American Rivers ♦ Audubon Mississippi ♦ Healthy Gulf National Audubon Society ♦ Sierra Club ♦ Sierra Club Mississippi

January 11, 2021

Re: Comments on the Final Supplement No. 2 To The 1982 Yazoo Area Pump Project Final Environmental Impact Statement

Distances from Wells to Mississippi River Channel

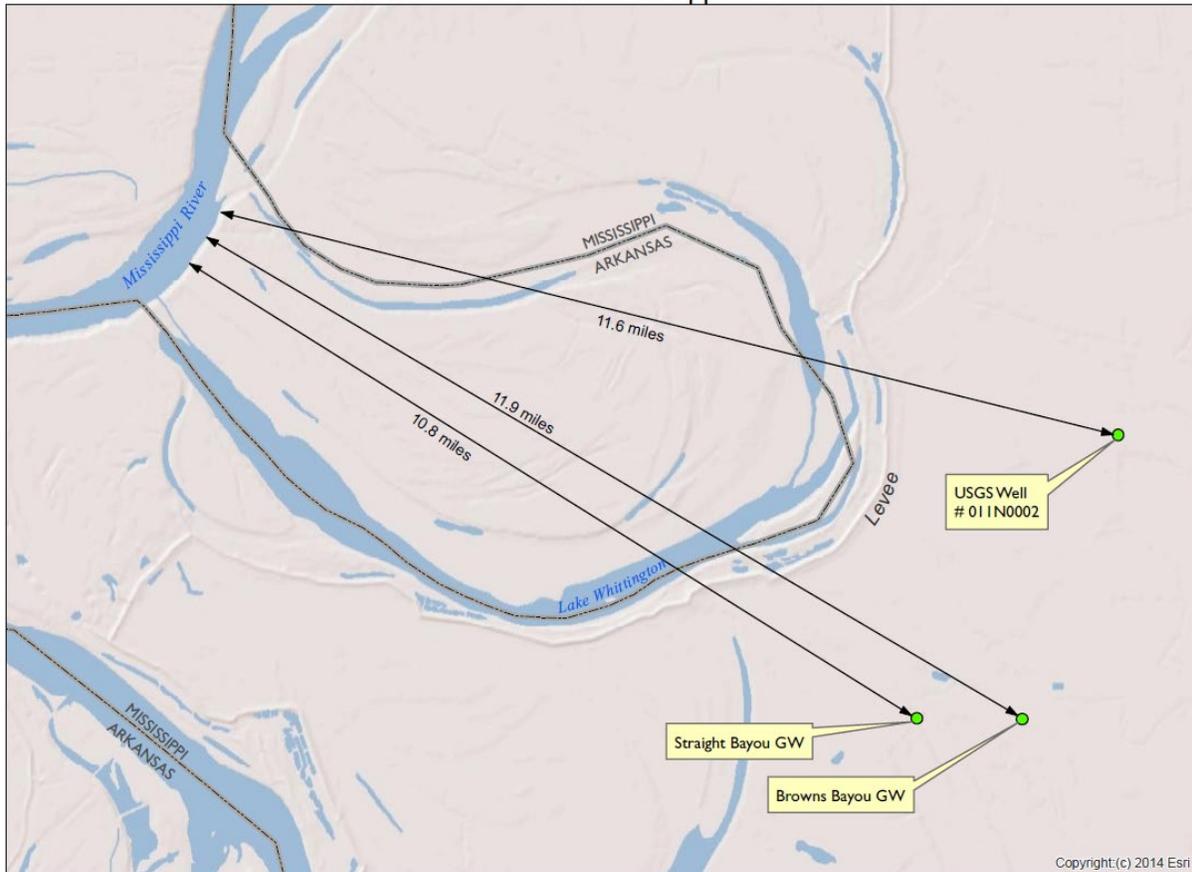
Yet, the Corps responded to neither the Comprehensive Plan nor the monitoring data provided by the Conservation Organizations. Instead, the FSEIS relies on a 2001 USGS study for the proposition that “ground water recharge occurs within five miles of the Mississippi River.”⁴¹ But that study is of no assistance because the Corps proposes to locate wells more than five miles away from the Mississippi River Channel, as depicted below.

These wells are thus in an area beyond the influence of the River, as shown by *both* the 2001 USGS study and the Comprehensive Plan. In fact, the adjacent USGS groundwater monitoring well shows a significant decline in groundwater levels over time, proving that the River is not recharging this area.⁴² The Corps’ proposal to drill additional wells will therefore deplete the aquifer and further drawdown baseflows, causing adverse impacts which the Corps has entirely failed to address.

YAZOO BACKWATER 2019 FLOOD DAMAGES*

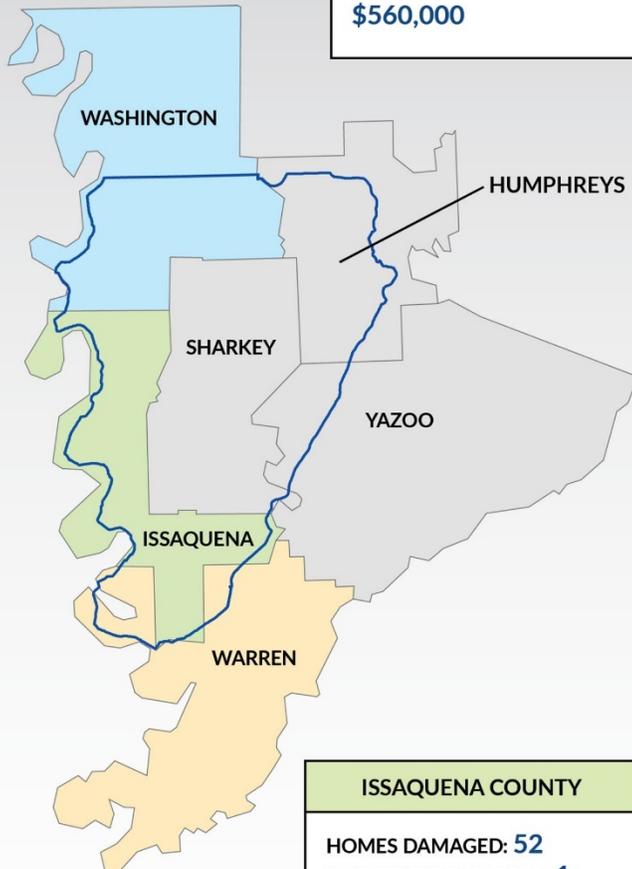
During the 2019 flood, structural damages within the Yazoo Backwater counties were highly concentrated with **76% of all structural damage** and **85% of all structural monetary damages** occurring in Warren County, which includes the Eagle Lake community and extensive areas located outside of the boundaries of the Yazoo Backwater Area (see Figure below). In 2019, relatively few structures were affected by flooding in Issaquena and Sharkey counties, the two counties located entirely within the Yazoo Backwater Area, according to Mississippi Emergency Management data. Within Issaquena and Sharkey counties a total of 53 homes and 19 mobile homes were affected. Of those, 27 homes had only minor or very minor damage. Data for other counties include large areas that would not be affected by the Pumps.

During the prolonged 2019 flood, homes and businesses in the counties that make up the Yazoo Backwater Area sustained \$12.3 million in structural damage. This damage was concentrated in Warren County (including the Eagle Lake community). Warren County sustained 85% of the monetary damage. Flood mitigation, such as elevating structures, purchasing floodplain easements, and elevating flood-prone roads, is rarely practiced in the Yazoo Backwater Area.
